TOWN OF MILFORD

Administrative Review

Date: April 7, 2021
To: Jason Plourde, Chair, Zoning Board of Adjustment
From: Lincoln Daley, Community Development Director
Subject: **Case #2021-09:** Michael and Michelle Sacco, 14 Falconer Avenue, Milford Tax Map 17, Lot 3 – Special Exception Application

Aerial Photos of Subject Property:

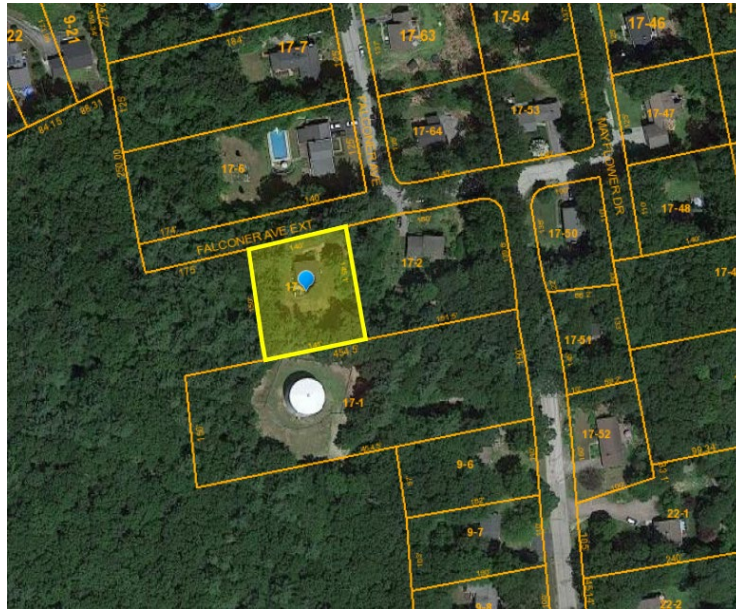
1. Existing Conditions:
 - a. The subject property is approximately .47 acres in area with approximately 140 linear feet of frontage on Falconer Avenue.

- b. The property consists of a 2-story, 3 bedroom, single-family residence and is serviced by municipal sewer and water.
 - c. The subject property is situated in an established single-family residential area and directly abuts Town conservation land. To the west of the subject property lies dedicated Town open space. The property is bounded to the north and east by residential uses. To the south of the subject property is the Town property.

2. The proposal calls for the construction of a 1,050 square foot addition to eastern side of the existing single-family residence. The proposed addition will include a 696 square foot accessory dwelling unit. Based on the aerial tax maps, the limits of the proposed residential expansion will exceed the 15 foot eastern dimensional setback.

7. No survey is available/had been provided to determine the distance/location of the addition to the property line. The applicant should verify the approximate distance to the side setback.
